Sygensys FRCR 2025 Consultation Response

Sygensys
7th April 2025

FRCR 2025 feedback

Figure 30 Annual number of minutes outside the standard ranges in Great Britain for 2019–2023

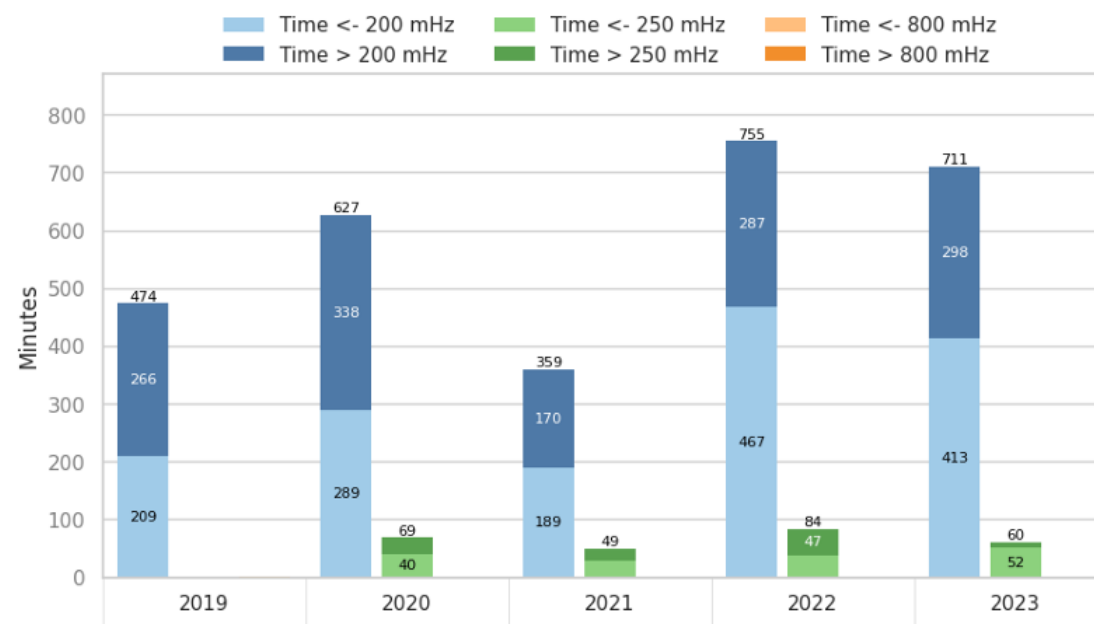
- Consider better reporting of trends vs time in future versions of FRCR
- For example see [ENTSO-e 2023 ALFC Report](#)

Potentially conflicting message/emphasis?
